Windows and door proposed for replacement

STAFF ANALYSIS

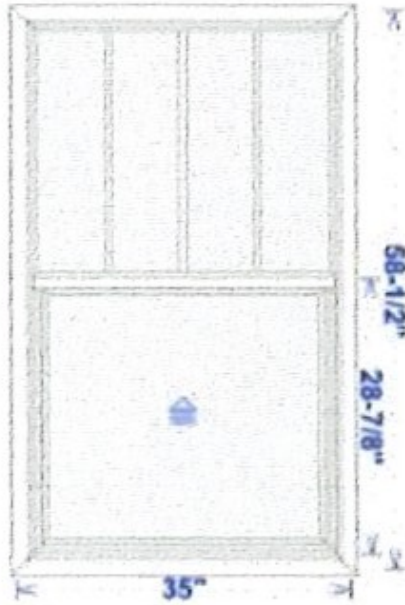
The current proposal seeks to remove wooden windows and door and install vinyl windows and aluminum door that are non-compatible with the materials appropriate to protect the historic integrity of the residence. However, the Secretary of the Interiors Standards for the Treatment of Historic Properties recommends "Undertaking work to prevent or minimize the loss, damage or destruction of the historic property while retaining and preserving significant features and the overall historic character of the building" and "Ensuring that, when planning work to adapt for natural hazards, all feasible alternatives are considered, and that options requiring the least alteration are considered first".

Based upon Secretary of Interior Standards 2, 5 and 6, staff recommends that the Board approve the request for installation of the new windows and door with condition that the new windows and door will have the same design style, and if possible, be made with the same material as the old one.
